RENESAS TECHNICAL UPDATE

| Product Category | Transistor | | Document No. | TN-WTR-A002A/E | Rev. | 1.00 |
| Title | CMFPAK-6 Packing specification change | | Information Category | Packing Change | | |

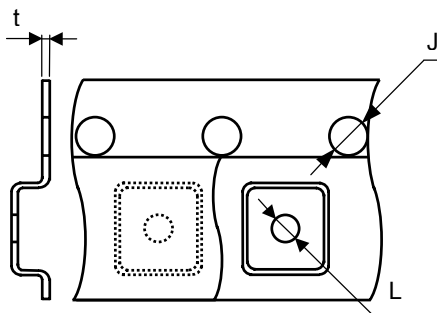
3. Cahanging of Packing

Points that are changed are as follow.

Material and other dimensions are not changed.

| Item | Symbol | Dimensions | | Unit | |
|--------------|--------------------|---------------|----------------------------|---------------------|----|
| Feeding hole | Diameter | J | $\phi 1.5 \pm 0.1 / -0.05$ | $\phi 1.55 \pm 0.1$ | mm |
| Carrier tape | Thickness | t | 0.2 ± 0.05 | 0.25 ± 0.05 | mm |
| | Emboss center hole | L | $\phi 1.05 \pm 0.15$ | $\phi 1.05 \pm 0.1$ | |
